bgdc lol		
x4nw.space/xp/xam		
xan		
Sheet: /		
File: xam-main.kicad_sch		
Title: xam is xan's audio mux		
Size: A3	Date: 2023-11-03	Rev: 1
KiCad E.D.A. kicad-cli 7.99.0-unknown	Id: 1/7

Title: power supplies

Title: control logic

bgdc lol x4nw.space/xp/xam xan	
Sheet: /Phono/ File: Phono.kicad_sch	
Title: mm phono preamp	
Size: A4	Date: 2023-11-03
KiCad E.D.A. kicad-cli 7.99.0-unknown	Rev: 1 Id: 3/7

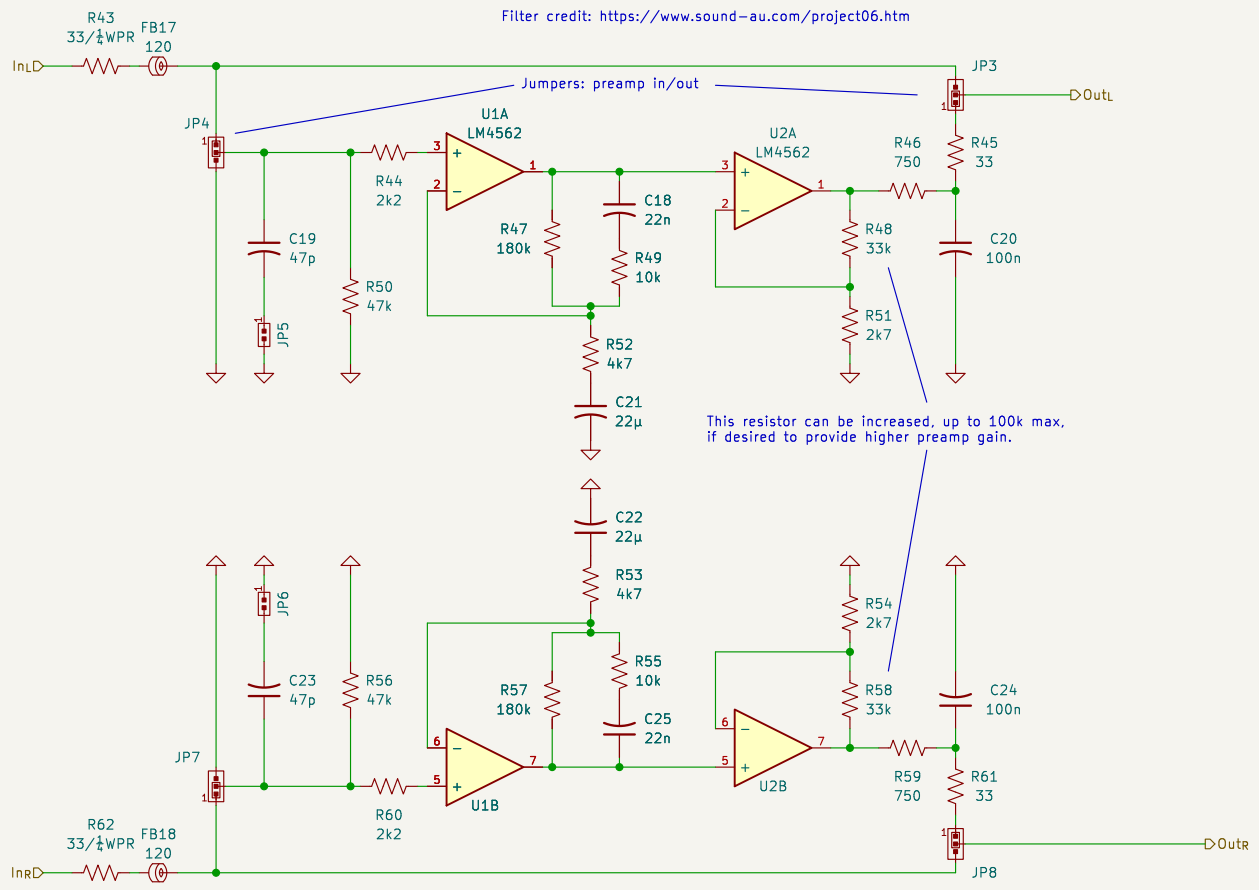
REWORK
Ensure pins 2 and 3 are shorted
This was missing on PCB first rev

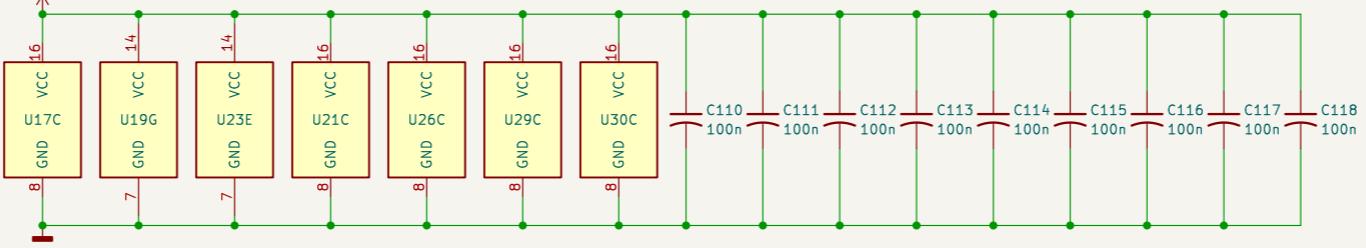
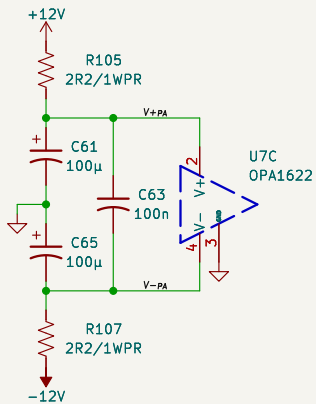
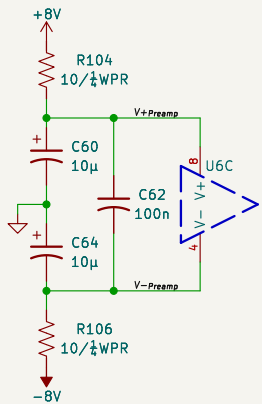
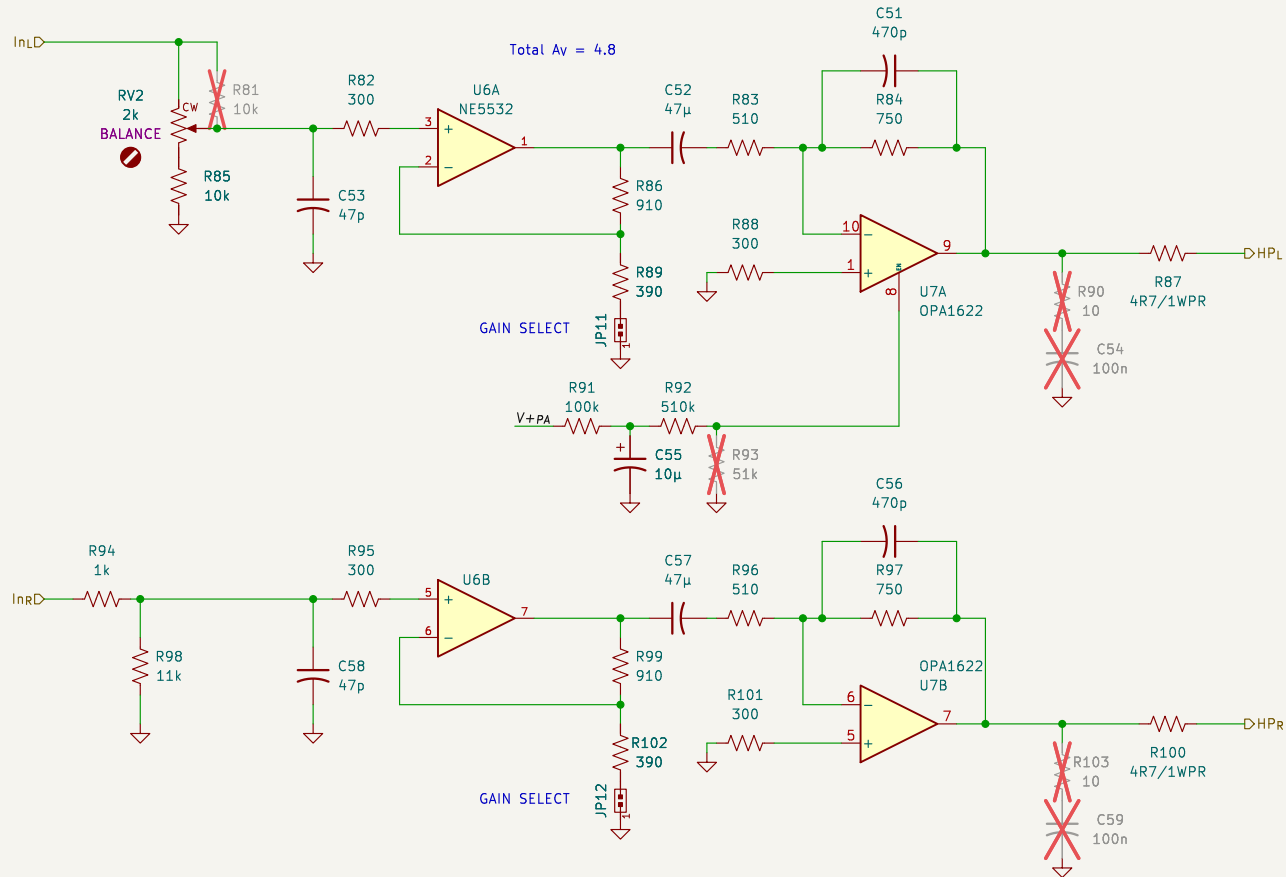
REWORK
U24.9 needs to connect to +12Vstby, not +12V. Lift pin and make new connection

REWORK
C904 220n R903 10k
PowerEn (optional)
